Development Review Committee Comments | 10/4/2022
Case PLAT22-0029
Caswell Addition (8900 Kirk Lane)

WRITTEN STATEMENT OF CONDITIONS

SHORT FORM FINAL PLAT
LOT 1, BLOCK A
CASWELL ADDITION

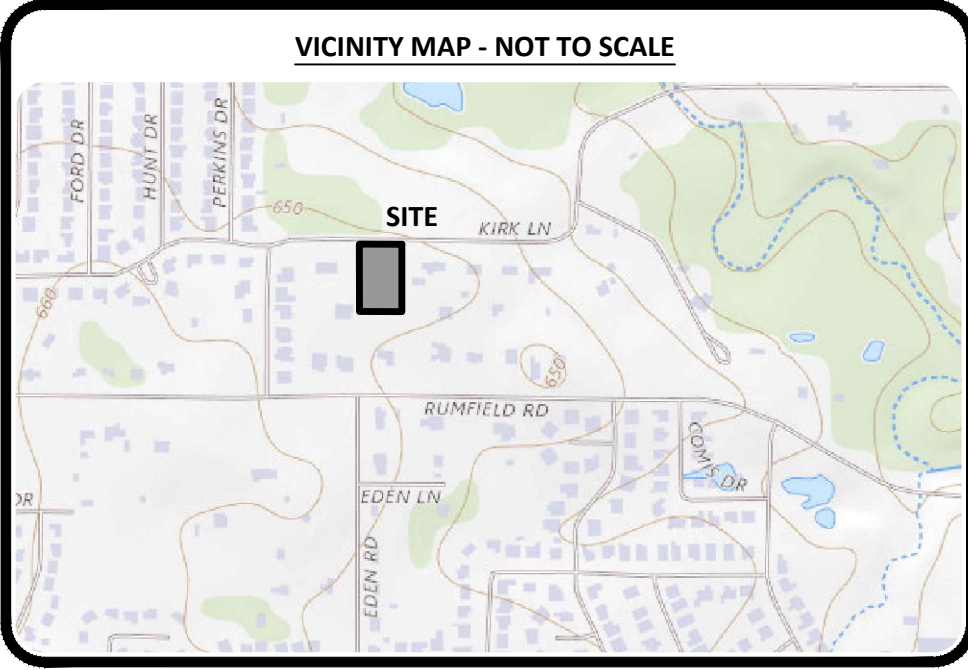
1. Informational. A zoning change application was submitted for this property in conjunction with the subdivision plat. The review of the plat was based in part on proposed zoning of R-1-S (Special Single-Family). *NRH Subdivision Regulations §110-384 (Conformity with zoning regulations)*

2. Remove the email addresses for the owner and surveyor from the plat. *NRH Subdivision Regulations §110-331 (Requirements for all plat drawings – ownership/developer)*

3. The County clerk recording block may be removed from the drawing. Plats are recorded electronically, and the block is not necessary. *NRH Subdivision Regulations §110-333 (Additional requirements for plat drawings – county certification)*

4. Change the block number to Block 1 on the drawing, the title block, and other relevant instances. The use of numbers instead of letters is the preferred block numbering format. *NRH Subdivision Regulations §110-331 (Requirements for all plat drawings – lot and block numbering)*

5. Update the title block to read **FINAL PLAT** rather than **SHORT FORM FINAL PLAT**. *NRH Subdivision Regulations §110-331 (Requirements for all plat drawings – title block)*

6. Add the following notes to the plat: *NRH Subdivision Regulations §110-331 (Requirements for all plat drawings – plat notes and conditions)*
 - a. No above ground franchise utility appurtenances are allowed in the fronts of the properties.

- b. The easements indicated on this plat are for the purpose of constructing, using, and maintaining public utilities including underground conduits, manholes, pipes, valves, posts, above ground cables, wires, or combinations thereof, together with the right of ingress and egress to operate and maintain the public utilities.

7. Kirk Lane is classified as an R2U Local Road on the Transportation Plan. An R2U roadway requires an ultimate right-of-way of 50 feet. Verify the existing right-of-way with established corner monuments on the north side of the street. Right-of-way dedication is required to establish a 50-foot existing right-of-way. Label the dimensions and area of the dedication on the drawing *NRH Subdivision Regulations §110-368 (Street right-of-way dedication) and §110-412 (Generally – rights-of-way)*

8. The proposed zoning for the property requires a front building line of 25 feet adjacent to the Kirk Lane frontage. Add the building line to the plat, as measured from the new property line based on the right-of-way dedication. *NRH Subdivision Regulations §110-331 (Requirements for all plat drawings – building setback lines)*

9. There is not a sanitary sewer main located along Kirk Lane adjacent to this property. What is the plan to provide sanitary sewer service to this lot? *NRH Subdivision Regulations §110-451 (Proportionality determination) and §110-446 (Adequate public facilities)*

1. Add the City case number near the bottom right corner of the drawing (Case PLAT22-0029).

There is no Sewer main along Kirk near this property. What is the plan for Sewer?

Change the block number to Block 1 on the drawing, the title block, and other relevant instances. The use of numbers instead of letters is the preferred block numbering format

Revise plat title to FINAL PLAT. The short form designation is not necessary.

Recommended that email addresses be removed since plat is a recorded public document
